Texas Commission on Environmental Quality Waste Permits Division Correspondence Cover Sheet

Facility Name: Fayette Power Project

RE: New Coal Combustion Residuals (CCR) Registration No. CCR1
Technical NOD Response – Request for Clarification
Lower Colorado River Authority Fayette Power Project – La Grange, Fayette County
Industrial Solid Waste Registration No. 31575
EPA Identification No. TXD083566547
Tracking No. 27214088; RN100226844/CN600253637

FIGURE 2
TYPICAL MONITORING
WELL COMPLETION DIAGRAM

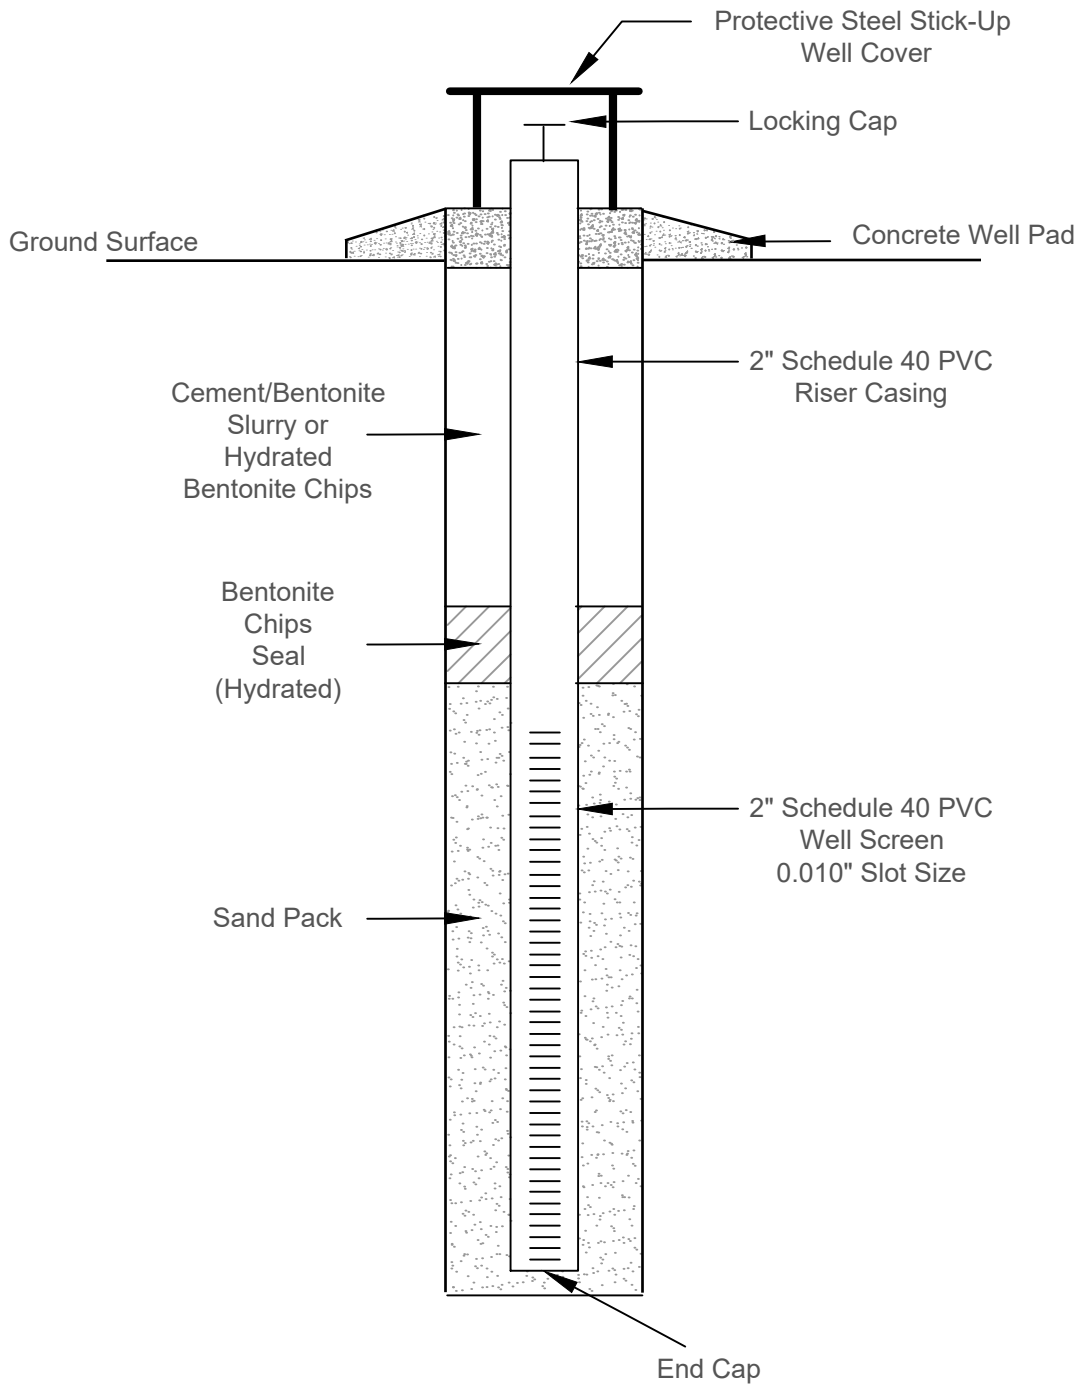
- i. Include a narrative that describes how the groundwater monitoring network will be installed at the waste boundary of the proposed CBL lateral expansion.

Information has been added to Attachment 4 stating that should lateral expansion of the landfill be necessary in the future, the groundwater monitoring network will be adjusted. The same general well design as current monitoring wells will be used to construct any future wells that may be needed. A schematic diagram has been added in Attachment 4 as Figure 2.

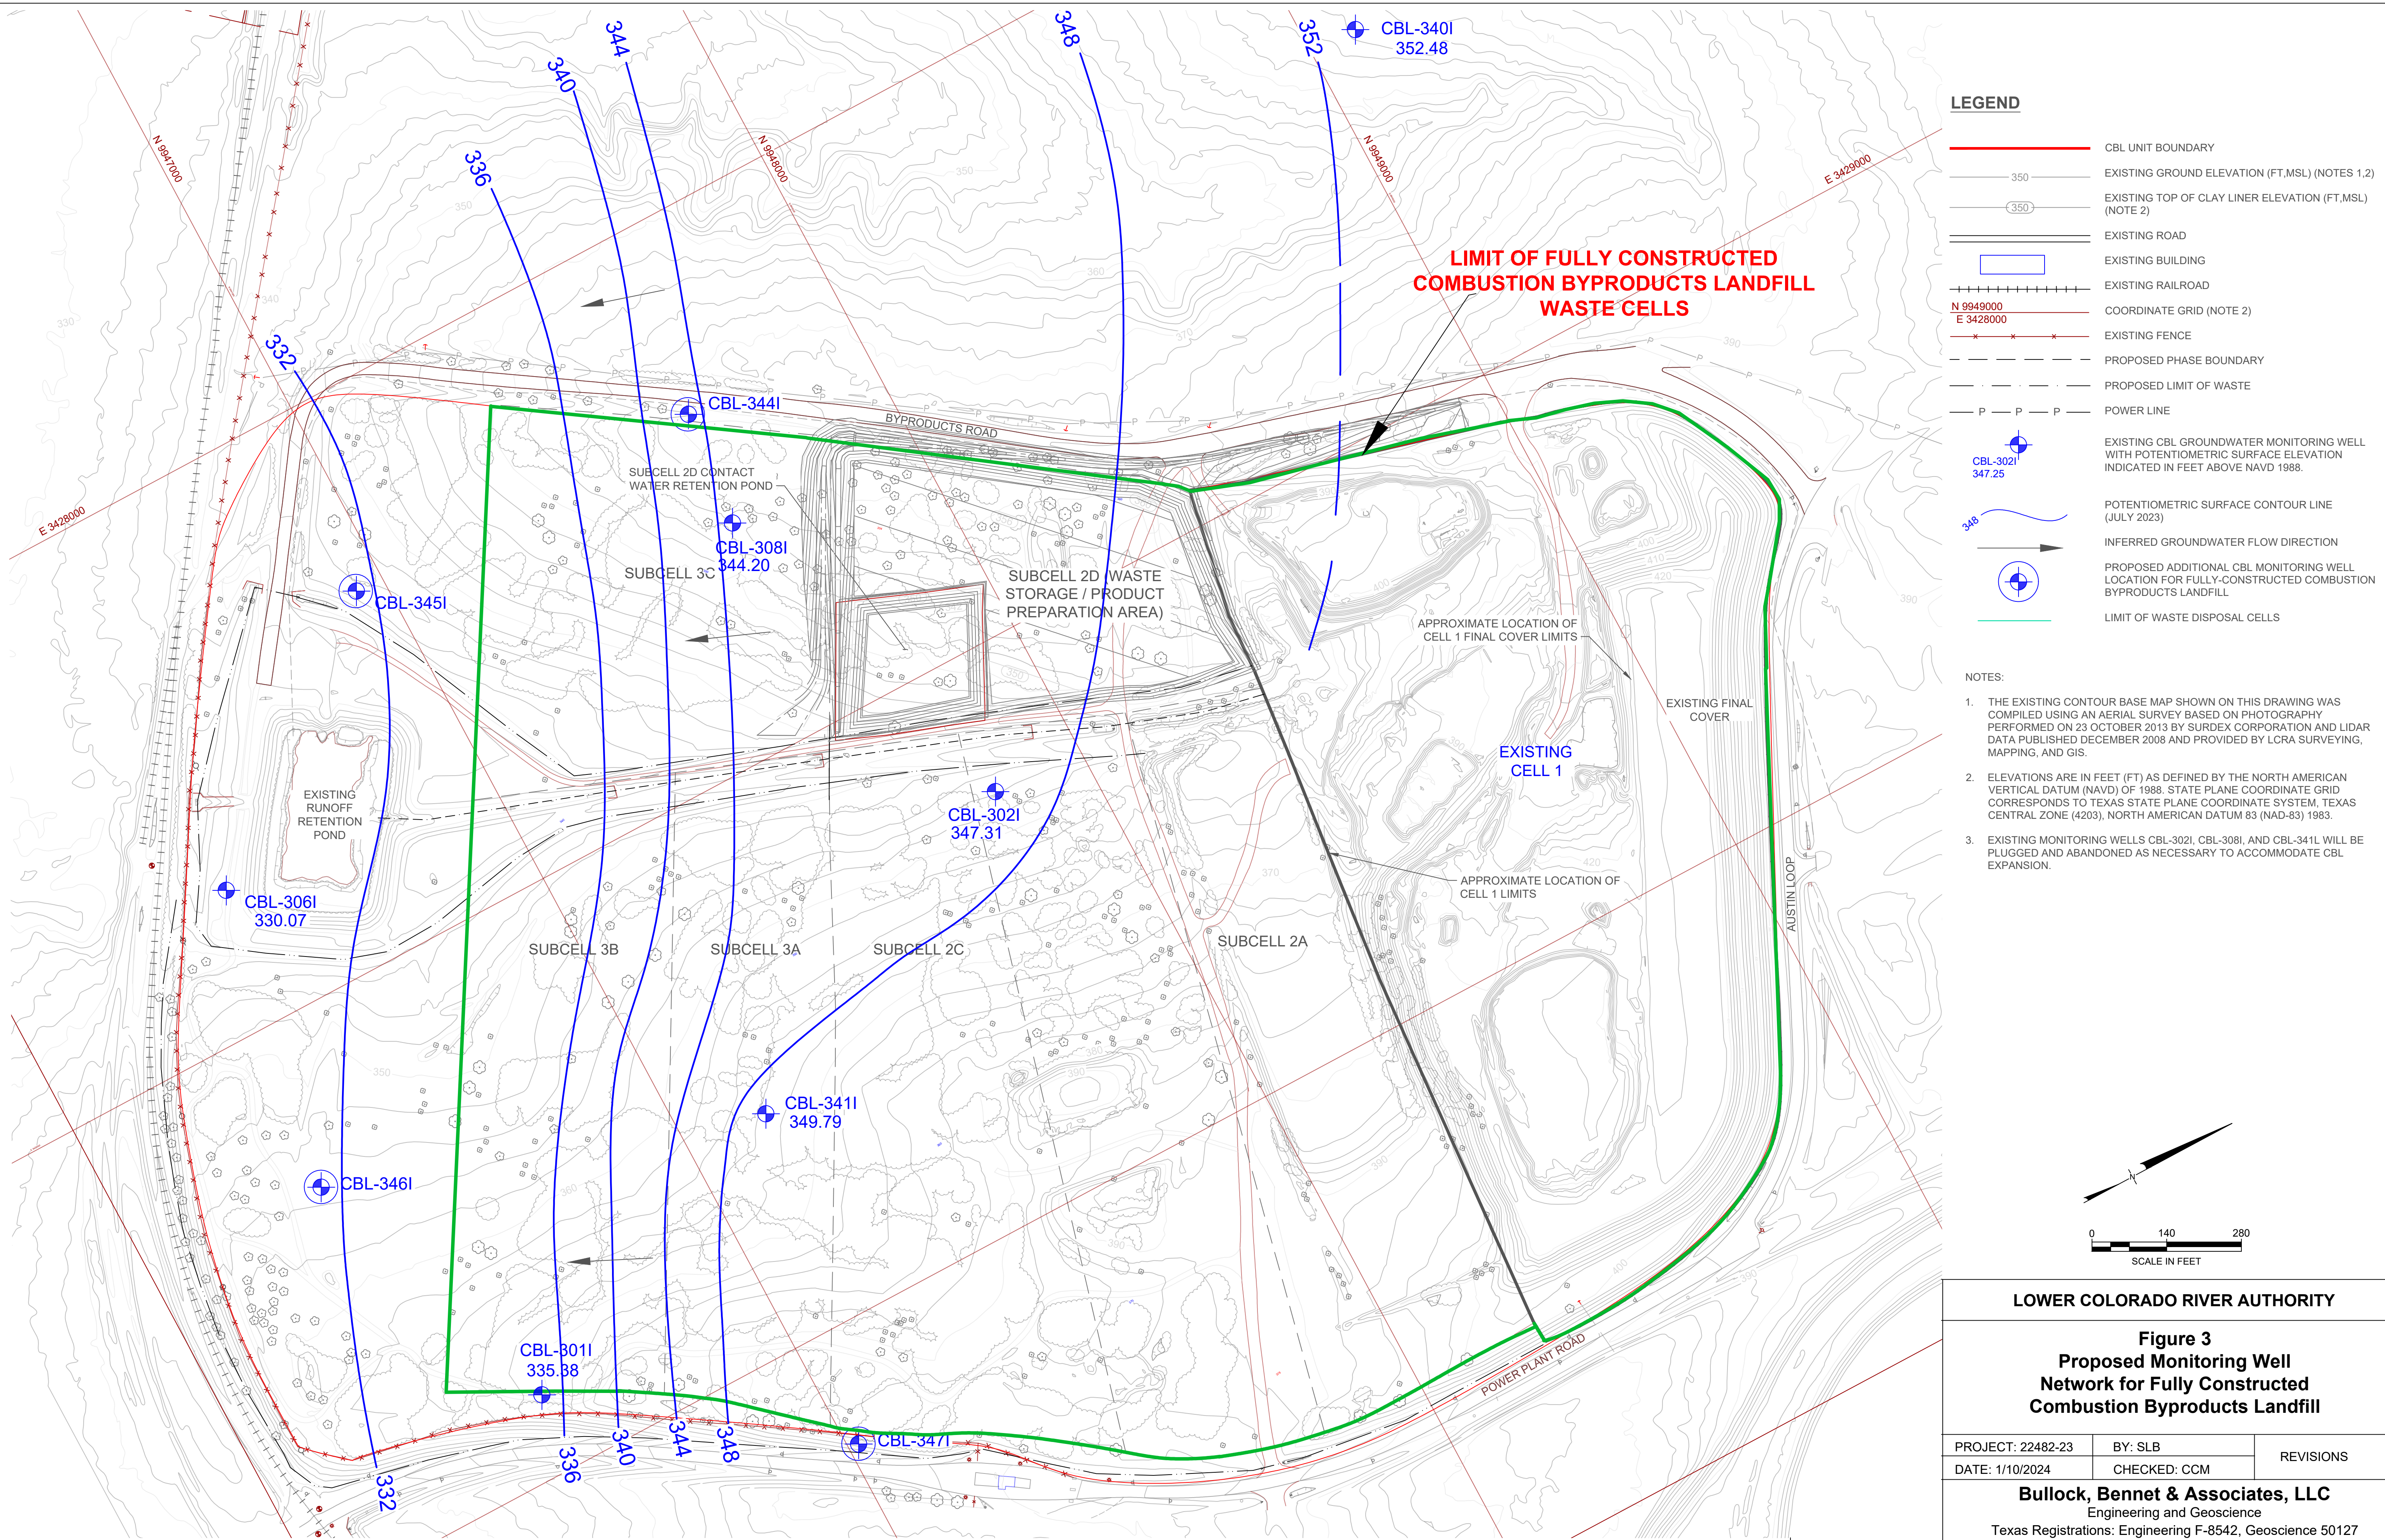
- ii. Provide a drawing of the CBL that depicts the location of the proposed groundwater monitoring wells at the waste boundary of the CBL proposed expansion area.

A drawing showing the proposed groundwater monitoring network at the future waste boundary is attached for inclusion in Attachment 4 as Figure 3.
